RE: ENERGY STAR™ Lamps v2.1 Draft 1 Comments

Comments on Draft 1 - ENERGY STAR™ Lamps v2.1

Figure 2: Typical normalized light output vs. junction temperature for L2C2-xxxxxxxExx00 at specified test current.

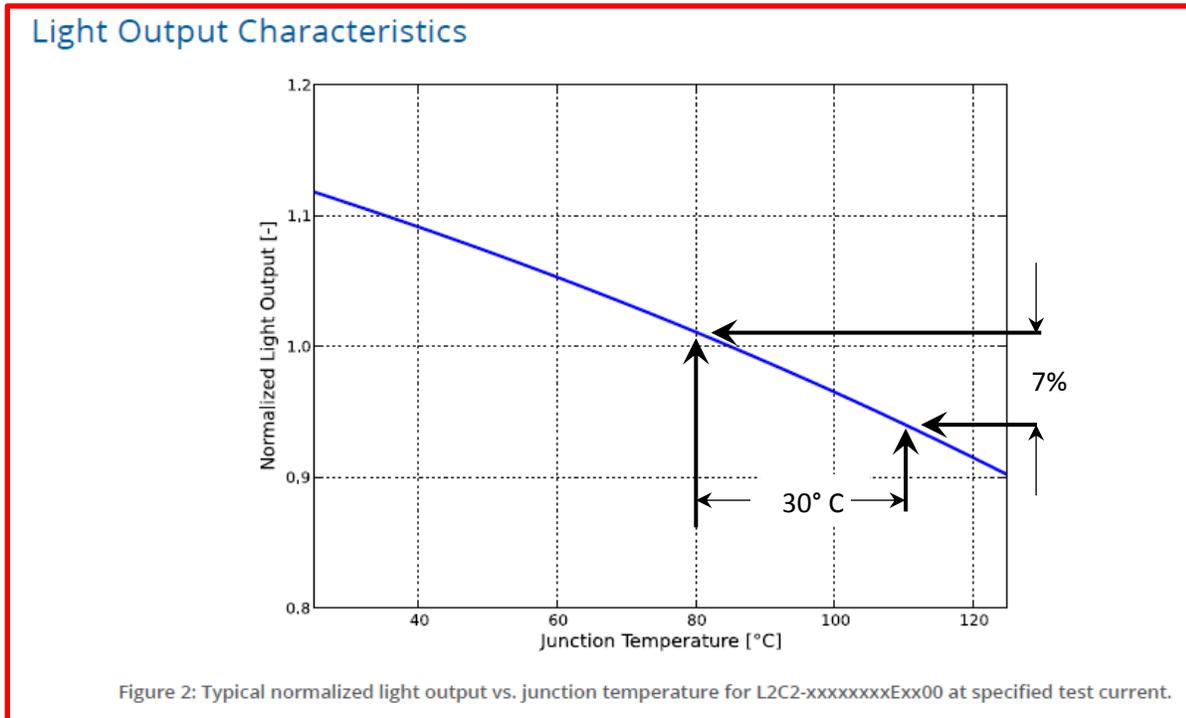
LED technology is now at a level that enables high-output directional LED lamps with input power that exceeds 20W. This is significant for two reasons: 1) Lamps with an input power over 20W must be tested at 55C instead of 45C,¹ and 2) Single optic designs that use chip-on-board (CoB) LEDs are more temperature sensitive than a multiple LED design. These effects combine to impose severe limits on lamps with chip-on-board LEDs.

The figure shows that CoB LEDs have a steep temperature dependence. Temperature dependence for discrete LEDs is typically not as steep. If the LED junction temperature is typically 80°C in the lamp, at 25°C ambient, then it will increase by about 30°C to 110°C at 55°C ambient. From the figure above, this unavoidable 30°C junction temperature increase will result in a 7% light output drop, if there are no other effects. (The increase will likely be more than 30°C, because LEDs are less efficacious at higher temperatures, resulting in more heat and a higher junction temperature. It may also be more for CoB LEDs from other manufacturers.) This leaves the lamp designer with less than 3% to work with, to include all other effects on light output, and design margins. These other effects (current variations with temperature, electronic component variations with temperature, etc.) are not insignificant. A 3% margin is too small and we strongly suggest that Energy Star allow a ratio of 0.85 for lamps greater than 20W. As this is a slight relaxation of the existing requirements, it would not affect currently certified products.

Case 1: Modulation depth 100 %

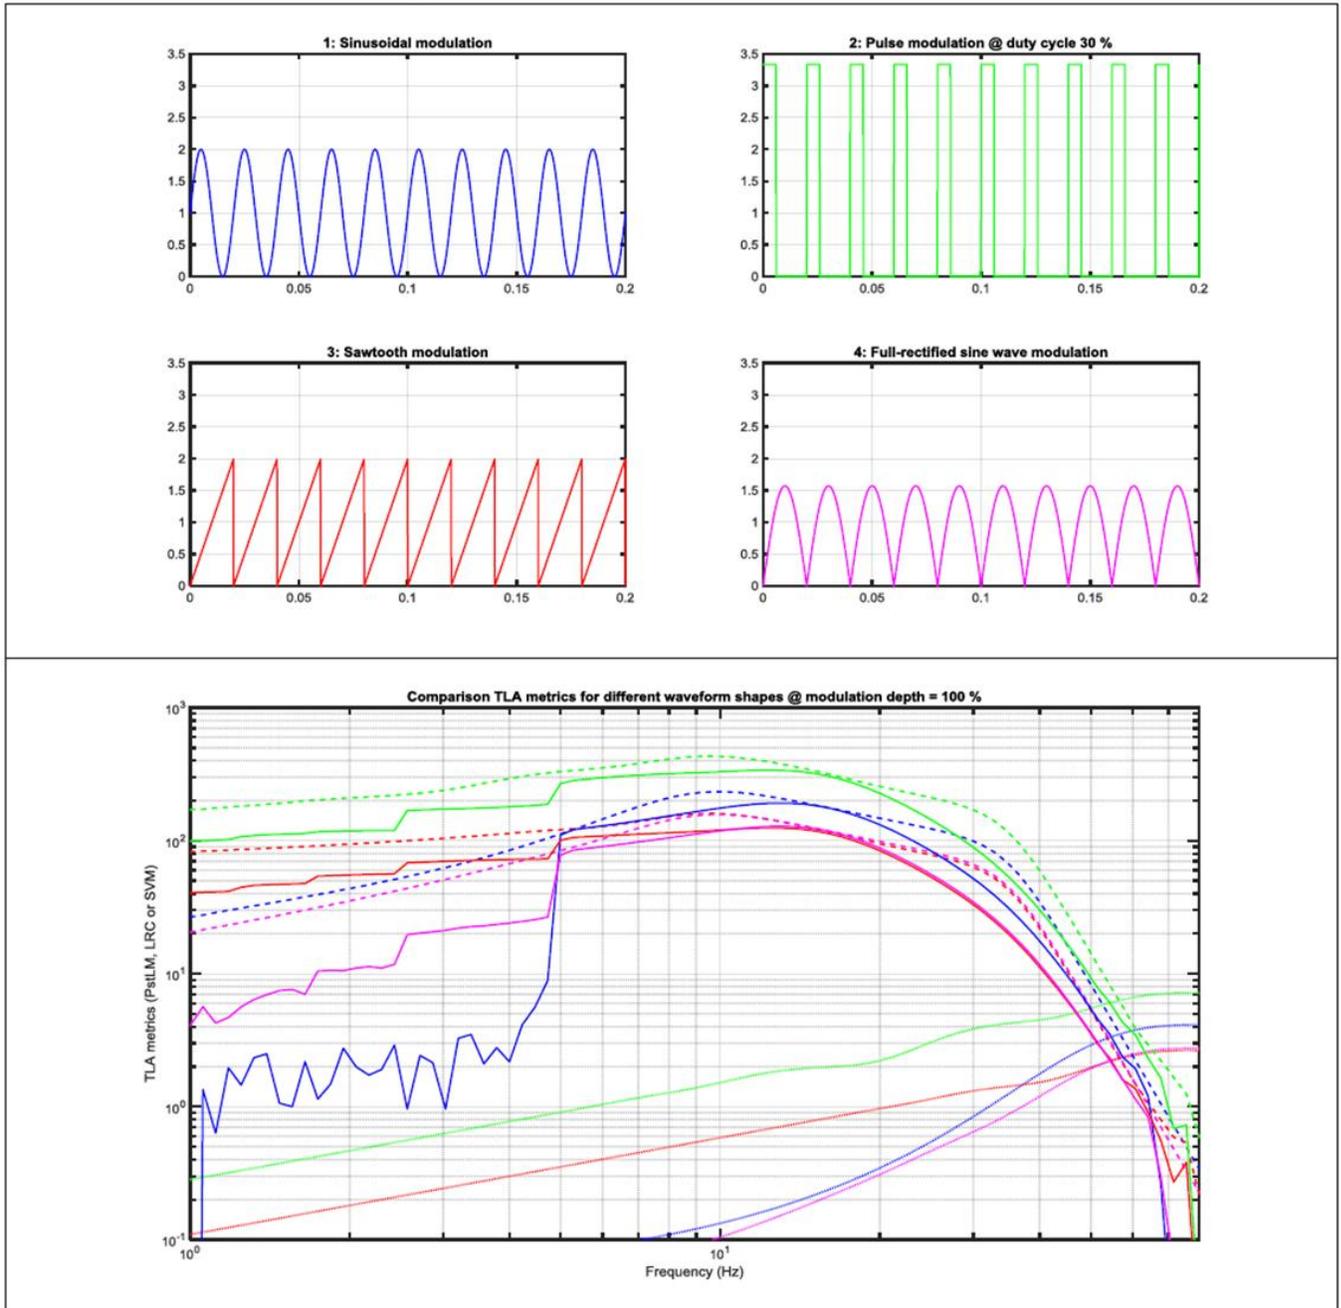
The three figures that follow compare the ASSIST, Pst and SVM methods over a range of 1 to 80 Hz on logarithmic scale. The solid lines are the ASSIST calculation. The dashed lines are the Pst calculation and the dotted lines are the SVM calculation (SVM is less relevant at the frequency ranges shown in the figures because it deals with stroboscopic effects). The sample rate was 20,000 samples/second. The waveform duration was 60 seconds. Frequencies between 1 and 80 Hz were used (80 points, logarithmically distributed). Results were calculated for four different simple waveforms (sine, 30% duty cycle pulses, triangle, and full-wave rectified sine).

The figures show that for all four waveforms, the ASSIST metric values are close to, but lower than the corresponding values of the Pst metric. Therefore, the Pst metric is more stringent than the ASSIST metric.
